TECHNICAL INFORMATION #928

ZIB-121

Re: Improvement of RF feedback for the IC706MK2G

Model: IC-706MK2G (All versions)

FILTER Board

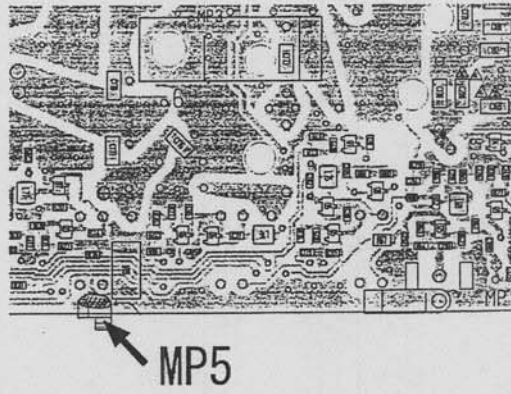
The RF feedback occurs when SWR condition get worse. This symptom appears on 18 and 21MHz bands mostly at the condition when the SWR is more than 2:1.

- 1) Add the following part on the FILTER board. (See the attached location.)

- 2) Re-adjust the position of all ground springs on the PLL board, ensure the good ground contact between PCB and chassis.

Board	Parts Number	Parts Number (Old)	Parts Number (New)	Action Taken
FILTER	MP5	None	8930055970	Added
			SPRING 2177 GND SPRING
